### ADDENDUM 1

## Austin Elementary School Heating & Air Condition (HVAC) Improvements Funded through the Elementary & Secondary Emergency Relief (ESSER) Funds May 31, 2022

## Addendum

**PROJECT** 218007.004 | Edinburg CISD - Stephen F. Austin ES - HVAC Improvements

SHEET NUMBER:	EP2.21
---------------	--------

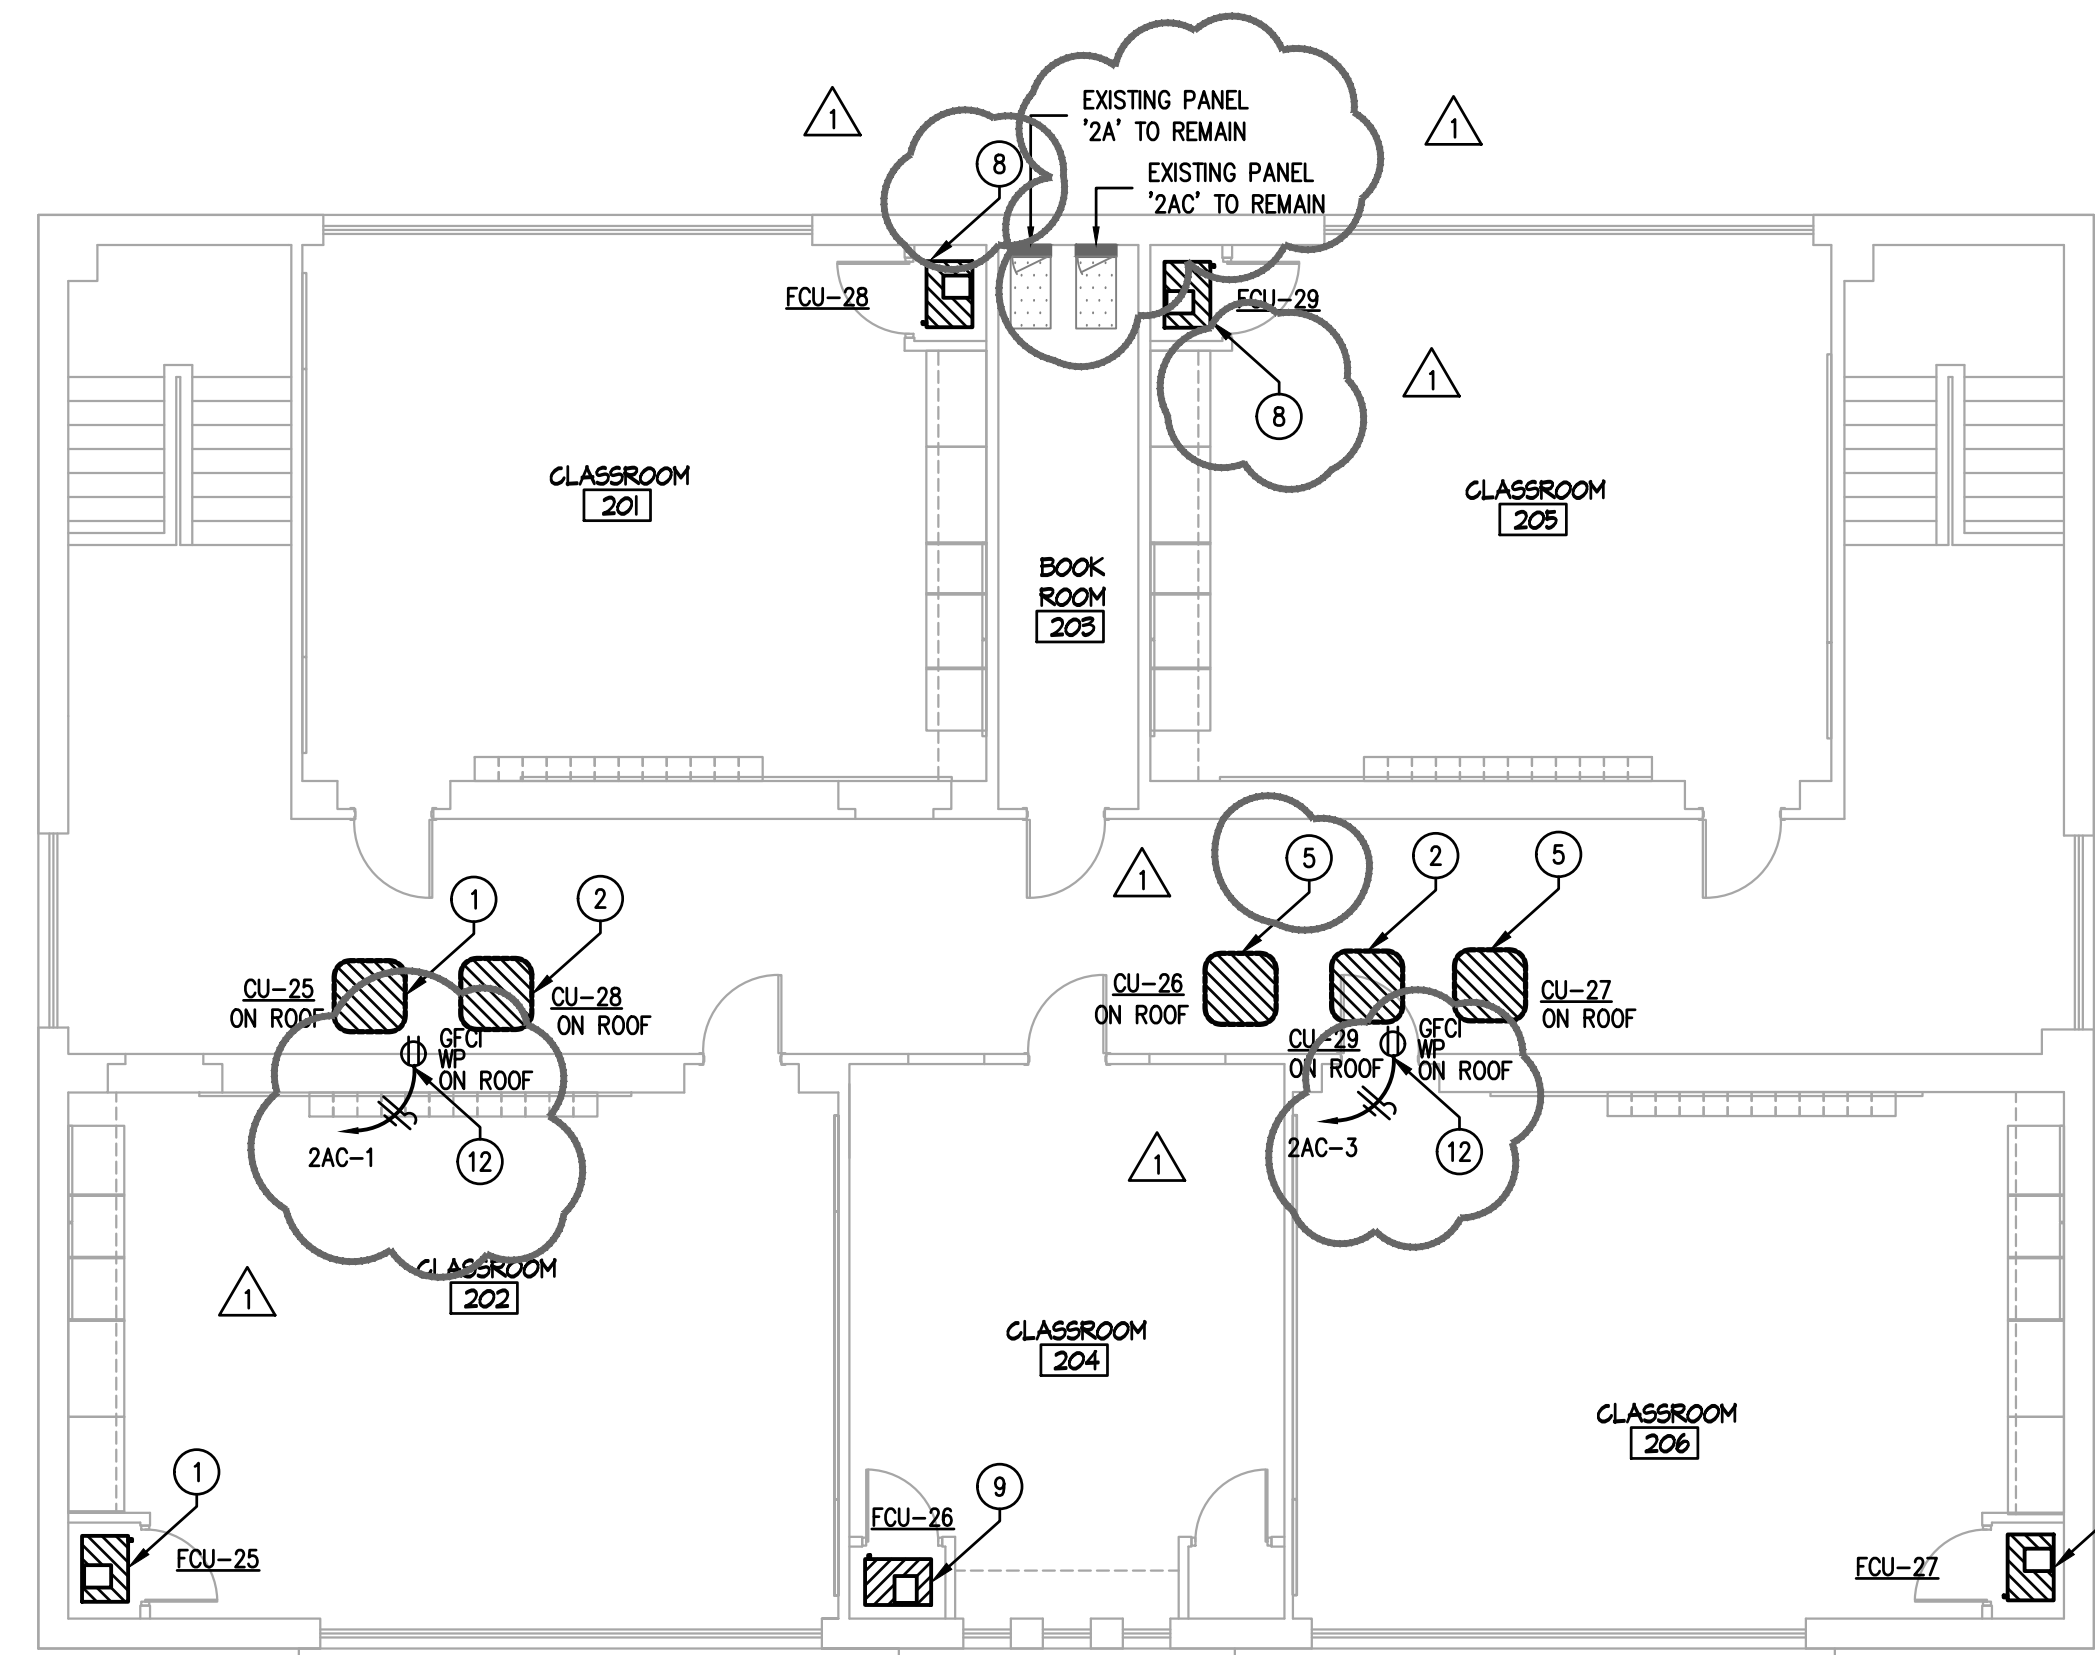
**Item 19 EP2.21 – LEVEL 2 ELECTRICAL POWER PLAN – MAIN BUILDING**

- A. Revised keyed notes.
- B. Revised noted equipment.
- C. Added maintenance receptacles for equipment.
- D. Added existing panel locations.
